APPLICATION NUMBER: 25/0248

PROPOSAL: DEMOLITION OF EXISTING VISITOR CENTRE, CONSTRUCTION OF NEW IMPROVED VISITOR CENTRE AND ASSOCIATED WORKS

SITE: Fourteen Locks Canal Centre Rogerstone Newport NP10 9GN

CONCERNS – REVISIONS REQUIRED

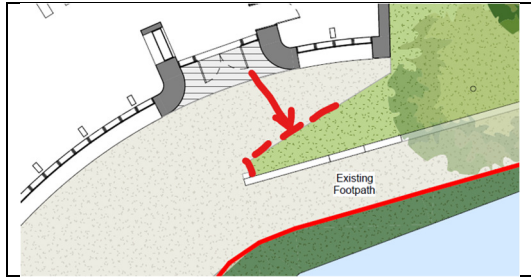
7. I recommend the grass area highlighted below is reviewed, this will take a lot of foot traffic and is unlikely to success unless raised.
